Product Information **PI**

Bulletin No: 100
Date: 7. July 2014
Product group: Industrial diaphragm gas meter
Distribution list: Affected customers
Author: Hans Arp

Design change of feet for diaphragm gas meters BK-G40 and BK-G65

current version

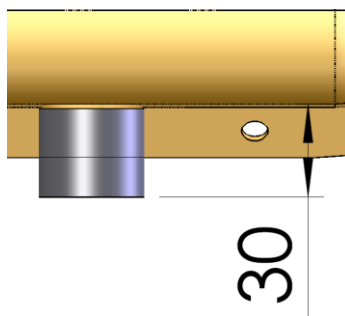
The following design changes improve the shock resistance and avoid scratches at the meter bottom and flange border.

Applied February – August 2014
solid foam material

new version

Introduction: August 2014
solid rubber material
interconnection with
Double Sided Tape by 3M
